UNITED STATES PATENT AND TRADEMARK OFFICE

APPLICATION NO.	FILING DATE	FIRST NAMED INVENTOR	ATTORNEY DOCKET NO.	CONFIRMATION NO.
10/084,608	02/26/2002	Norio Koma	349	4219
26021	7590	12/12/2005	EXAMINER	
HOGAN & HARTSON L.L.P. 500 S. GRAND AVENUE SUITE 1900 LOS ANGELES, CA 90071-2611			WANG, GEORGE Y	
			ART UNIT	PAPER NUMBER
			2871

Office Action Summary**Application No.**

DETAILED ACTION

Fig. 4

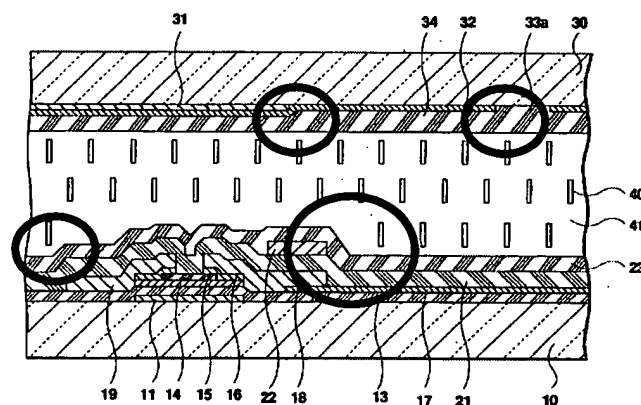
4. Regarding claims 15-16, Koma discloses the vertically aligned LCD as recited above, however, the reference fails to specifically disclose orientation controllers (23, 34; see circled areas in the reproduced figure below for convenience) with sloped projections extending along the longer edge of the electrode region and branching at both longitudinal ends of a corresponding one of the electrode regions toward the corner section of the electrode (23, 34; see circled areas).
